Town of Clayton
Technical Review Committee Meeting - FINAL Agenda
Wednesday, August 15, 2018 @ 9:00 AM
GS 223 - Clayton Town Hall

1. Please record the project number on the cover sheet (2018-62-SD). **As shown**
2. Do you intend to annex the property? **No**
3. Due to the volume of comments from staff, please note that this application will likely proceed to a 2nd TRC meeting once revisions are received. If this occurs, the application may be postponed accordingly until the plans have obtained required TRC certification to proceed for board review.

PRELIMINARY PLAN
FOR
KYL KNOLLS SUBDIVISION
TOWN OF CLAYTON - JOHNSTON COUNTY, N.C.

MAJOR MODIFICATION SUBDIVISION PLAN
(MAJOR MODIFICATION TO 2017-171-SD)

SHEET 2: EXISTING CONDITIONS

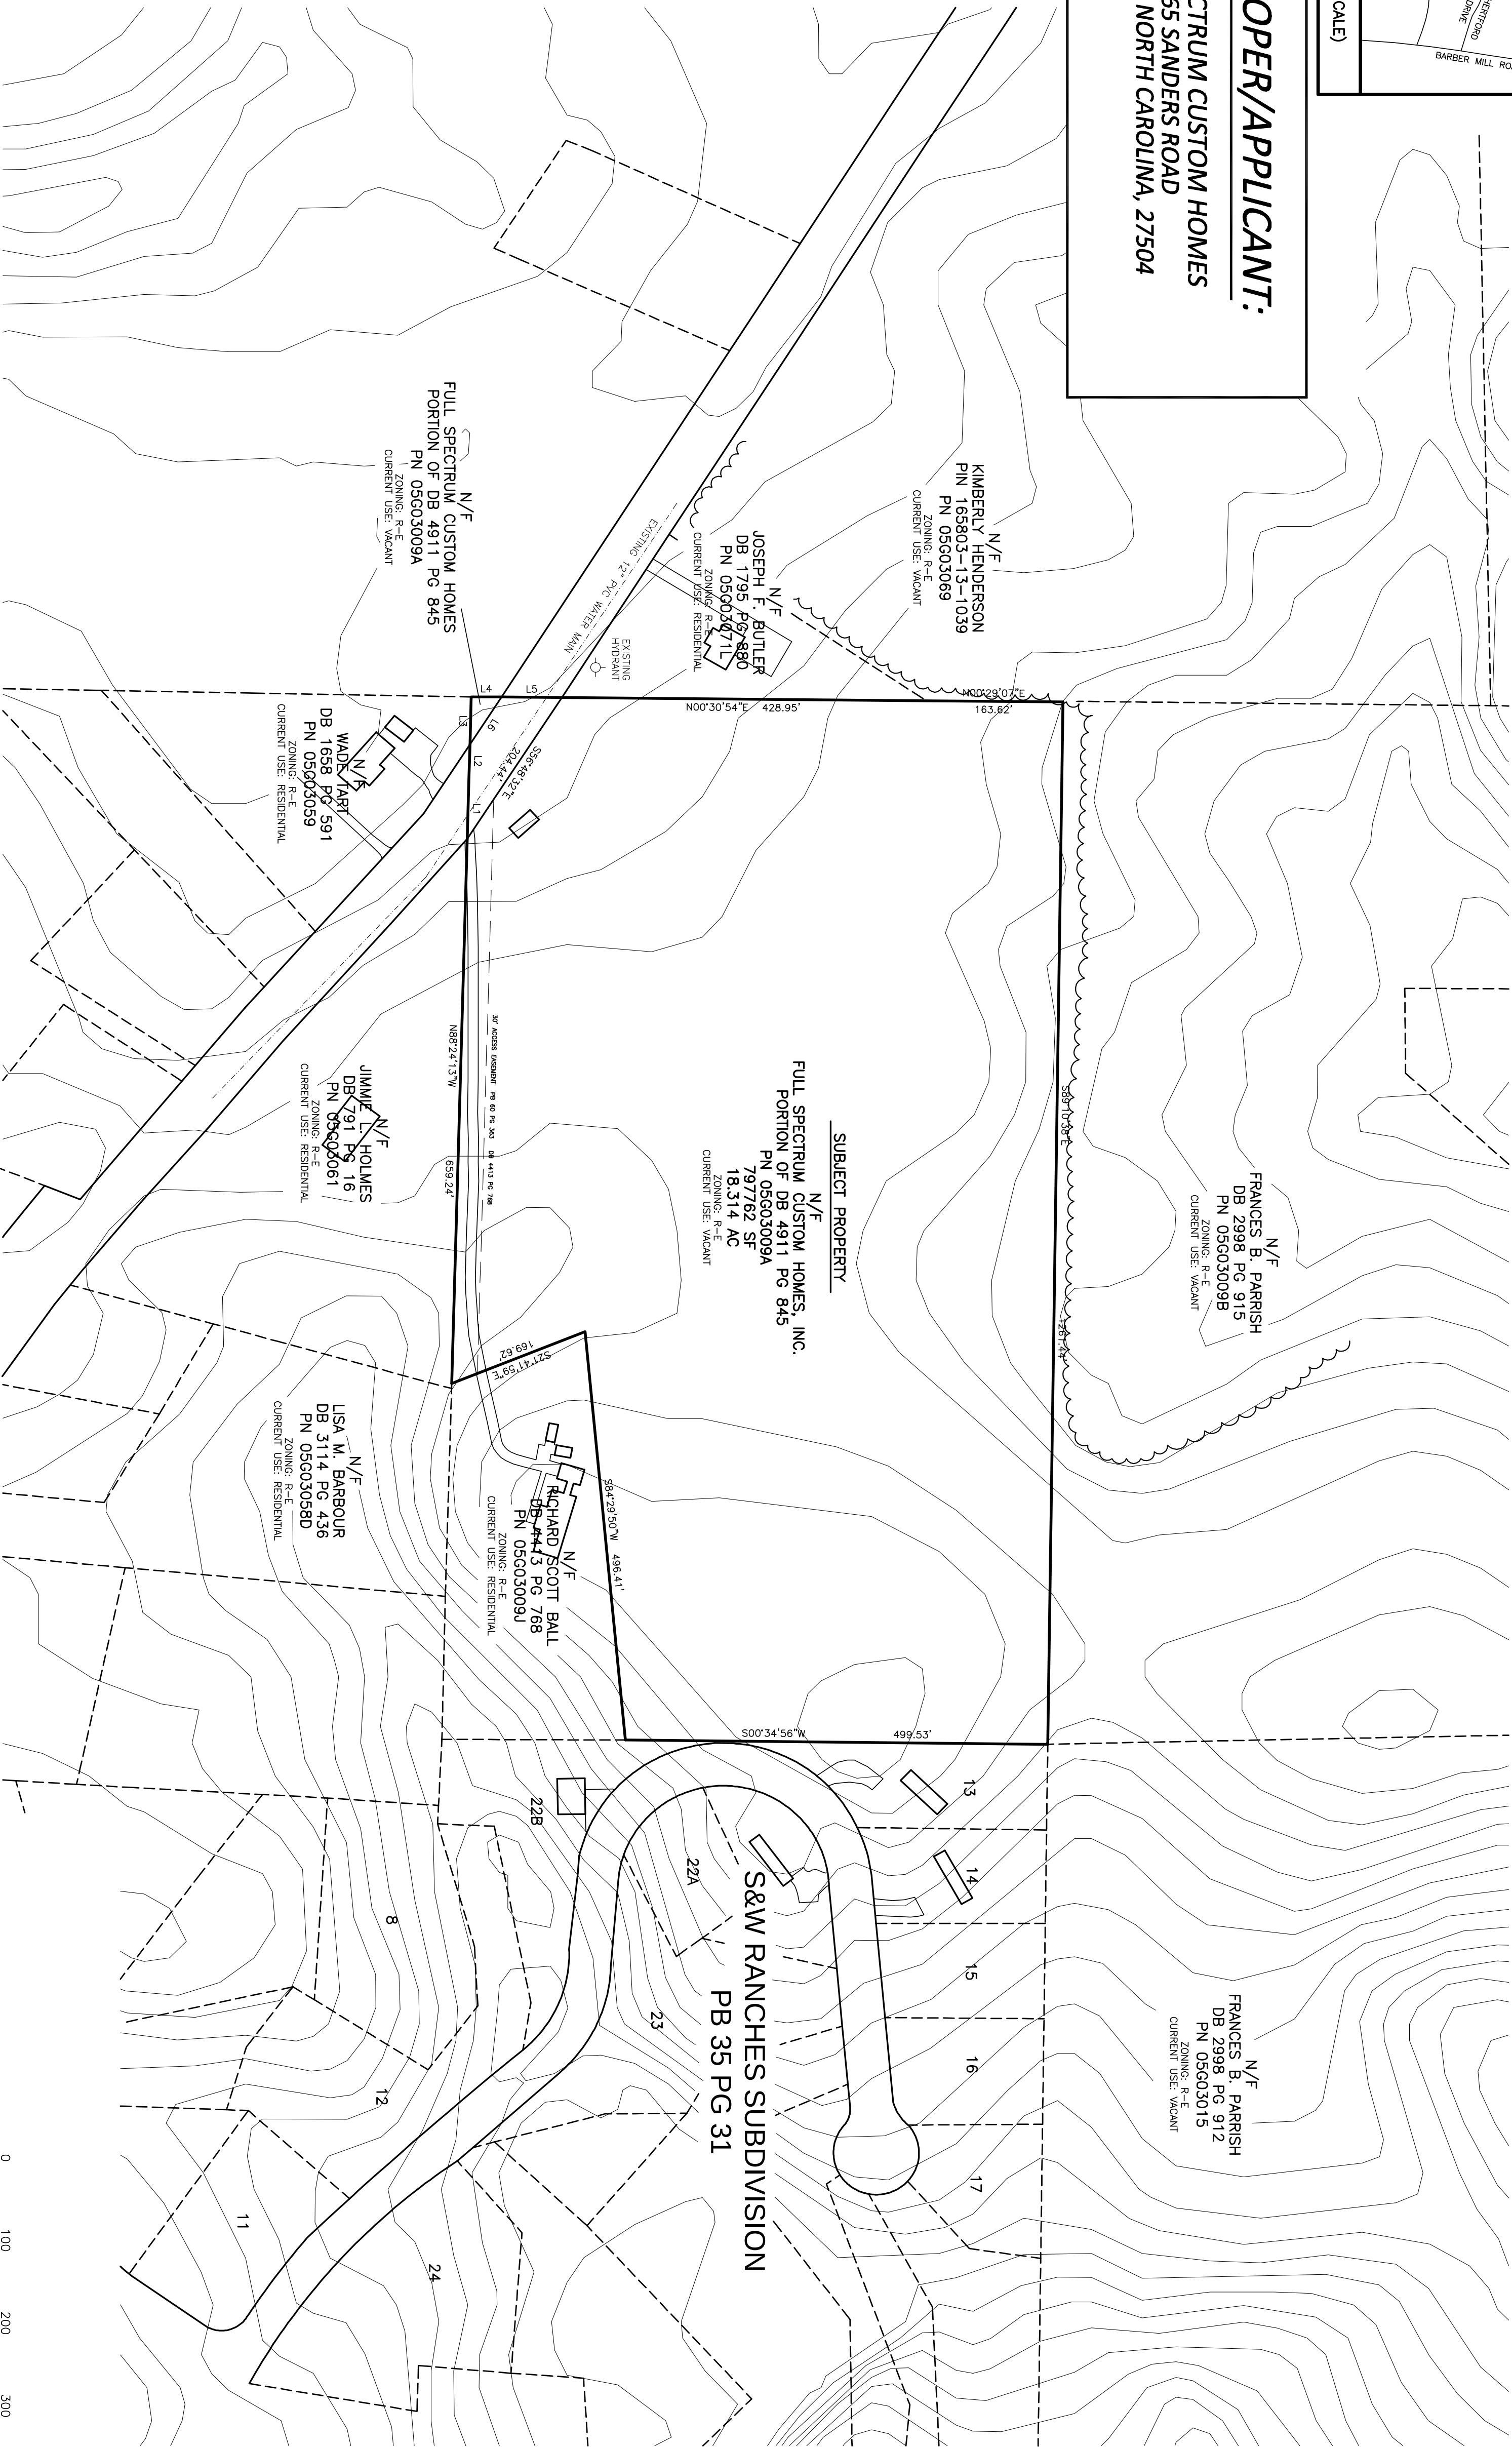
4. Please note that a signed and sealed boundary survey is required, as noted within the plan requirements checklist. Please revise the plans accordingly to include this.
5. Please revise the plans accordingly to include the following required items, as noted within the plans requirements checklist:
 - a. Existing structures on subject property **As shown**
 - b. Bearings and distances **As shown**
 - c. Existing structures within 100' **As shown**
 - d. Existing utilities within 100' **As shown**
 - e. Existing driveways and easements within 100' **As shown**

SHEET 3: SUBDIVISION

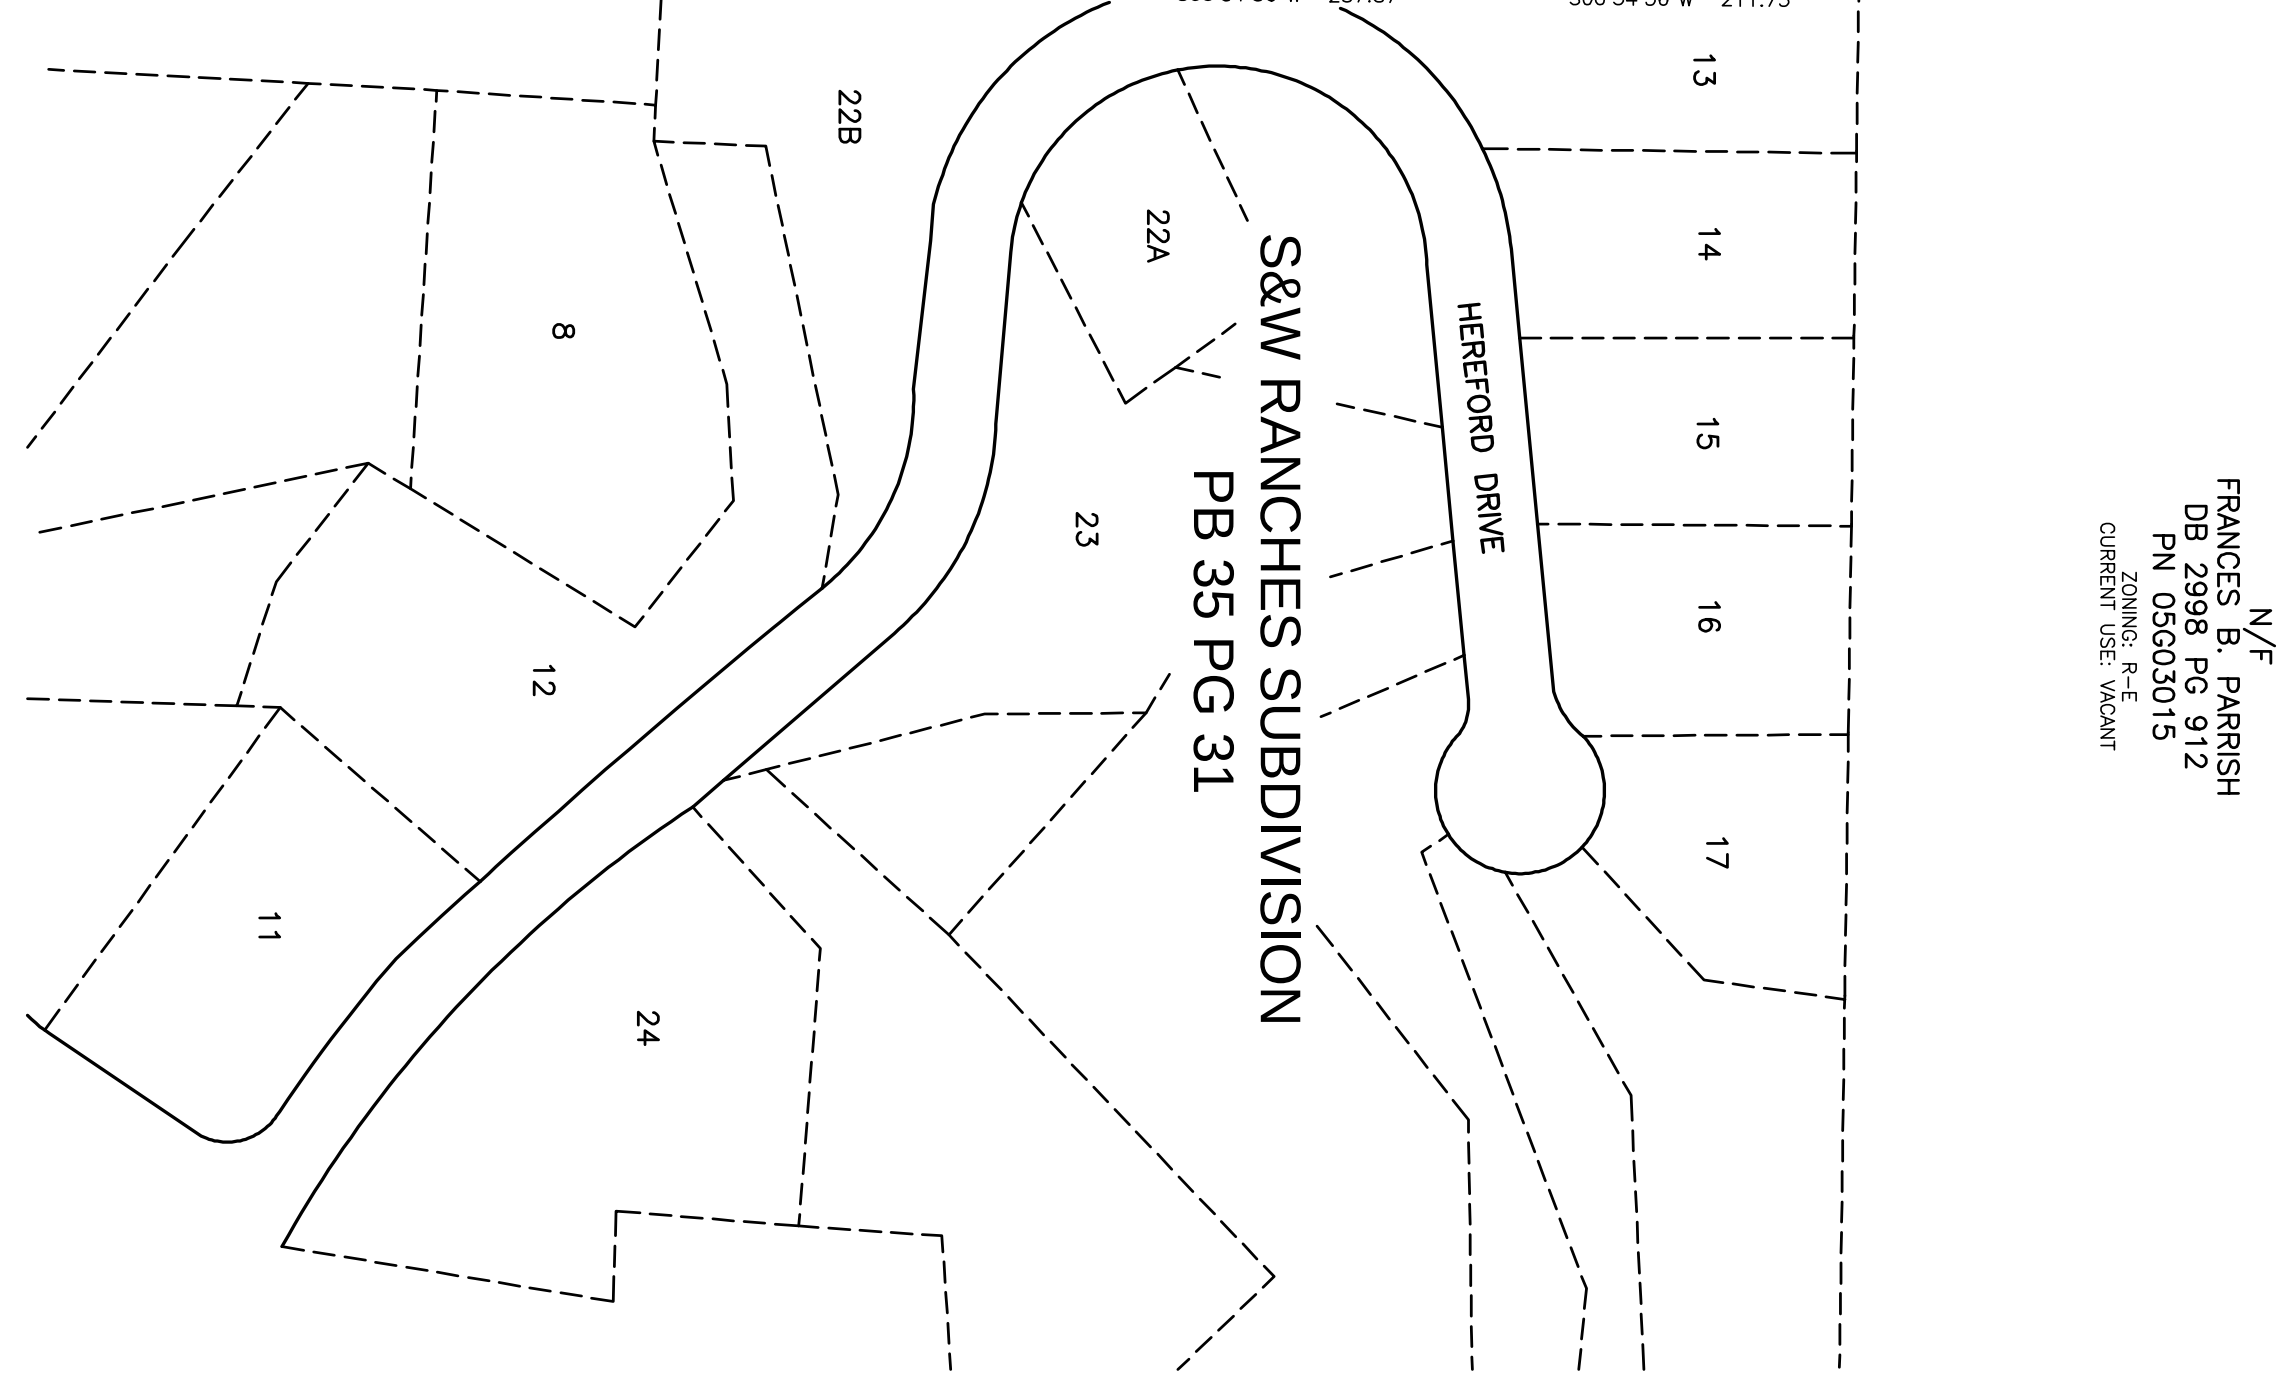
- d. Electric/water/sewer providers **As shown**
7. Will these lots be served by public water and septic or public water and sewer? It is unclear based upon how the plans are currently drawn. **As shown**

8. R-E Zoning Standards:
 - a. Please revise the minimum lot size to the size required within the UDC. The minimum lot size for lots served by public water and septic is 25,000 SF. The minimum lot size for lots served by water and sewer is 20,000 SF. Please revise accordingly. **Plan has been revised to correct this.**

9. Lots 10, 11, 12, and 13 do not meet the minimum lot width requirement for R-E zoning standards (80'). Please revise the plans accordingly. **80' lot width line shown on lots 10-13**

10. Lots 8 and 9 do not meet the minimum lot size requirement. Please see comment #7 above, and revise the plans accordingly to meet this requirement. **Plan has been revised to correct this.**

12. Please label the 30' access easement as "Existing" on the site plan, and label the record book and BE **As shown**
13. Please show and label safe sight triangles at the entrance off Amelia Church Road. **As shown**

14. Please show any propose roadway improvements on Amelia Church Road. **None**

SHEET 4: CBU SITE PLAN

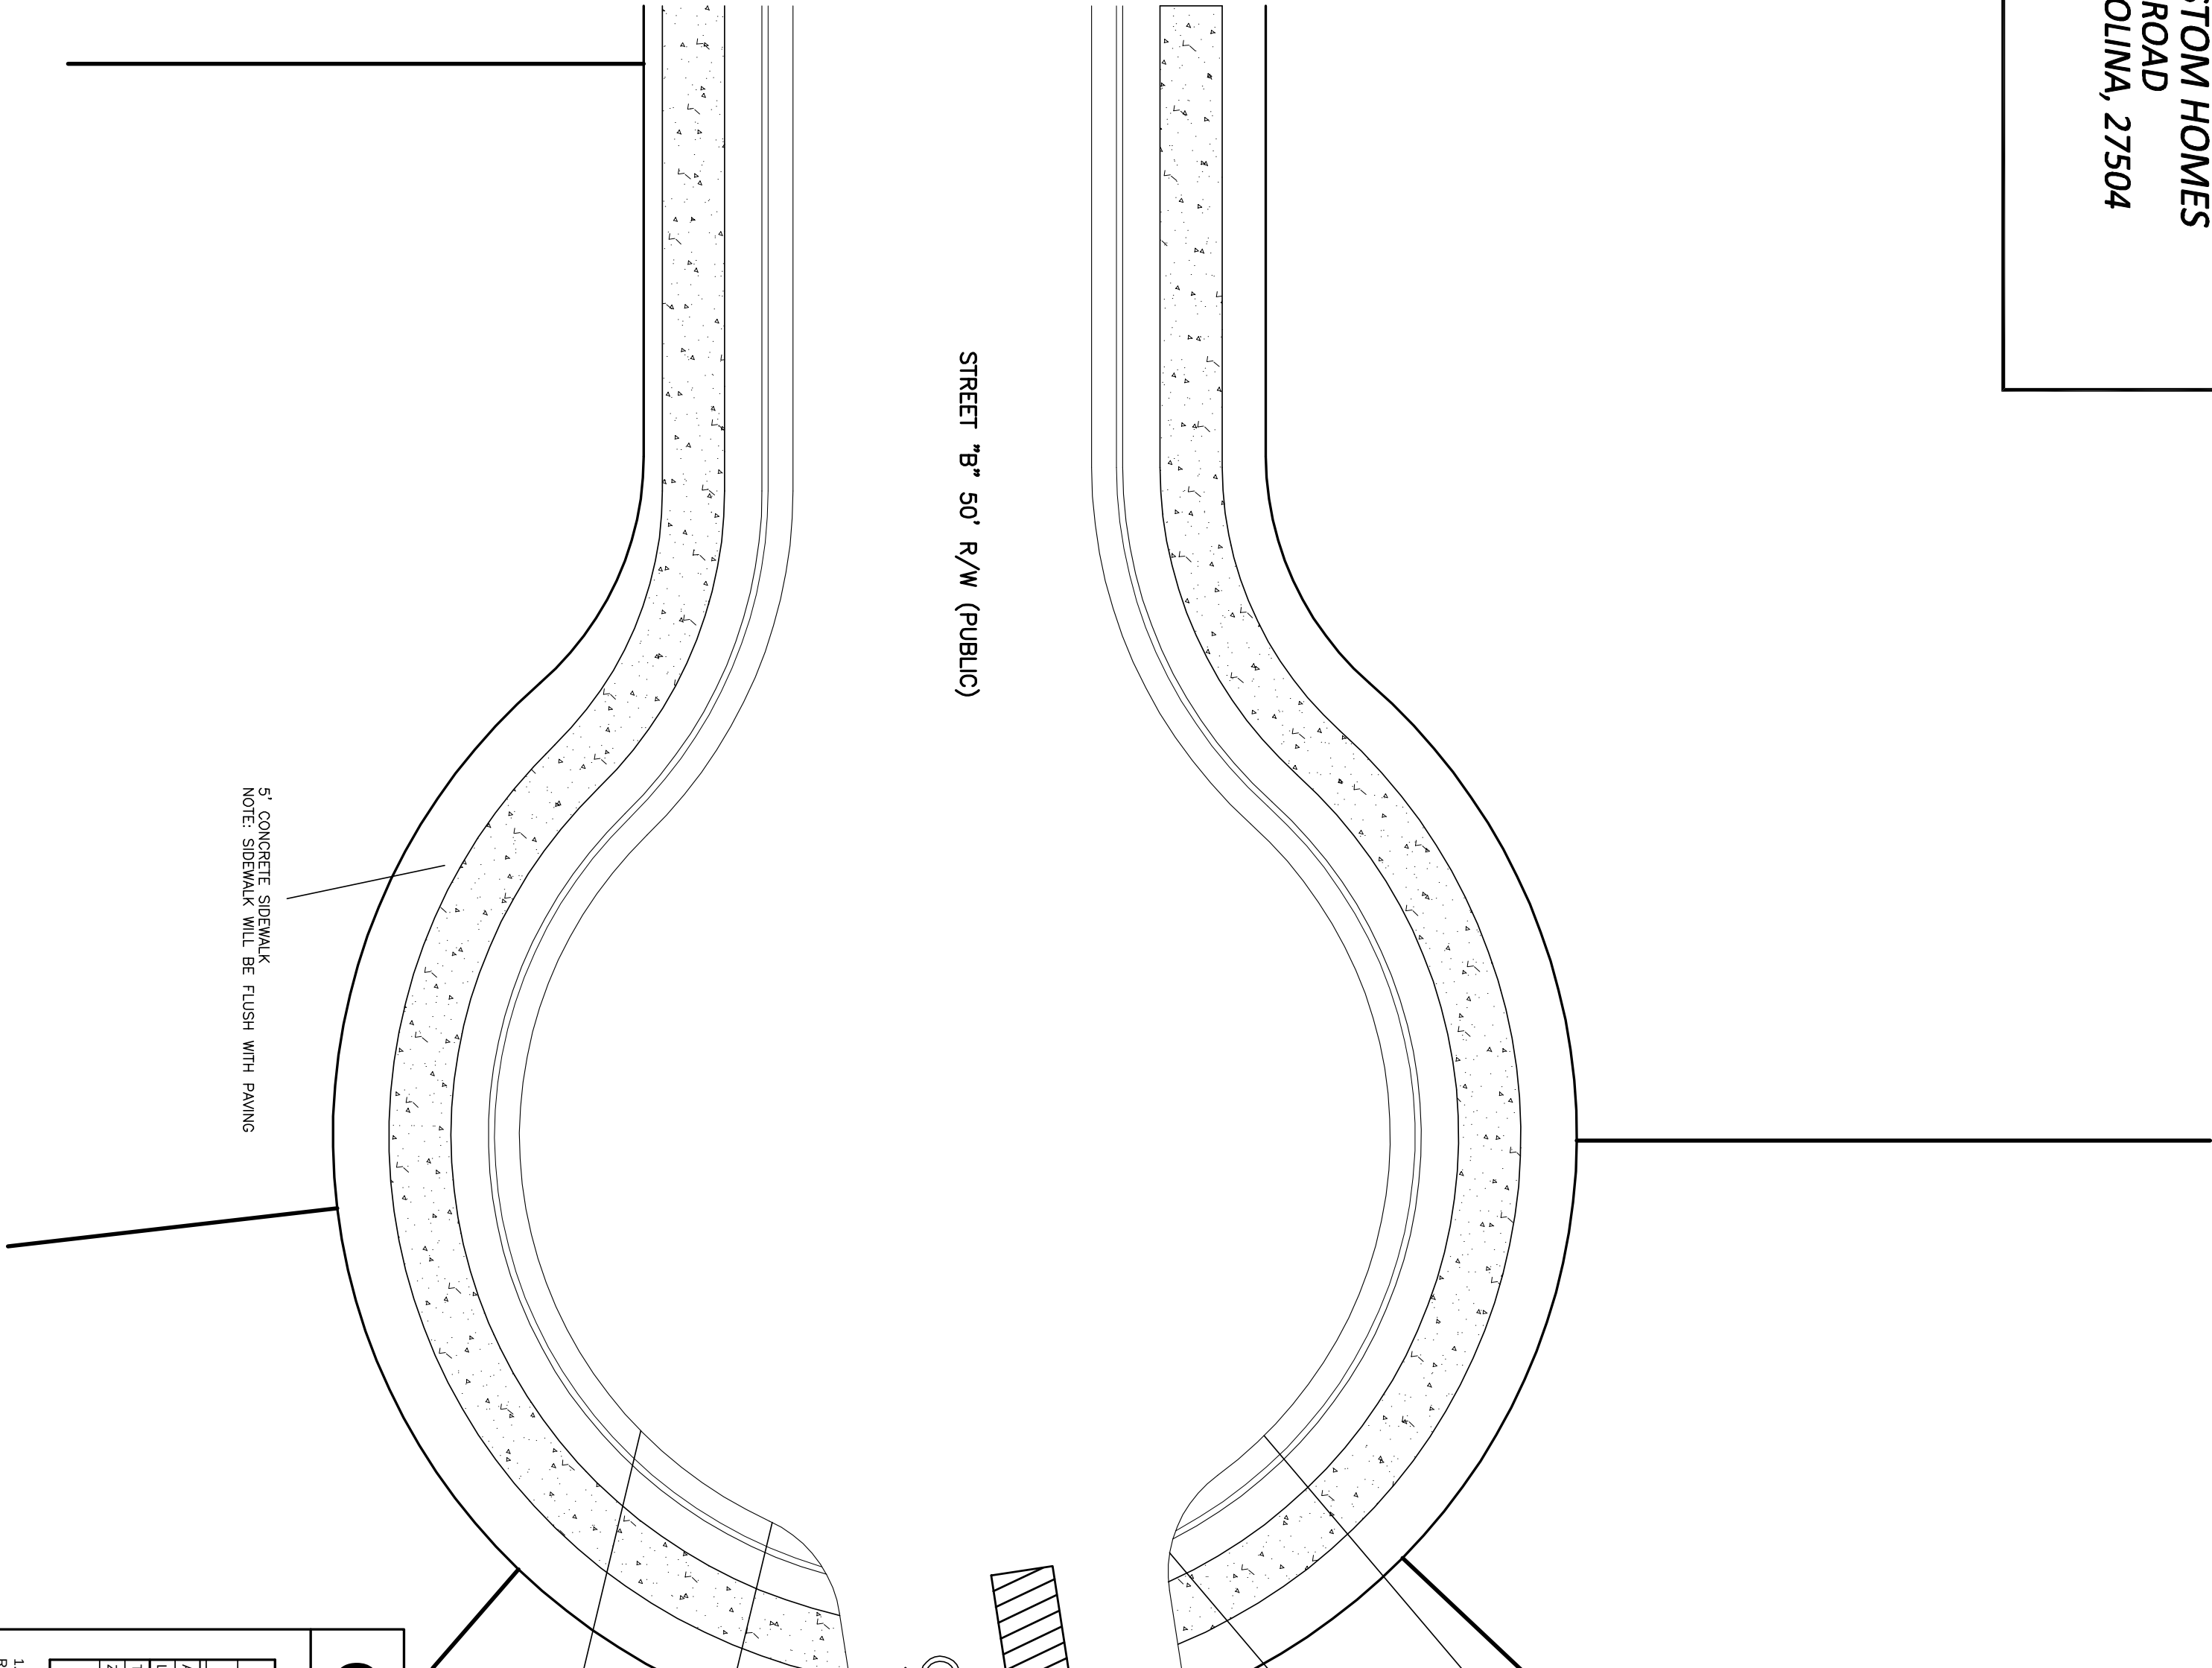
16. Where will the driveways for lots 11 and 12 be located? Please show on the plan. **As shown**
17. Will the proposed CBU landscaping be located within an easement? Who will maintain the landscaping? **As shown**
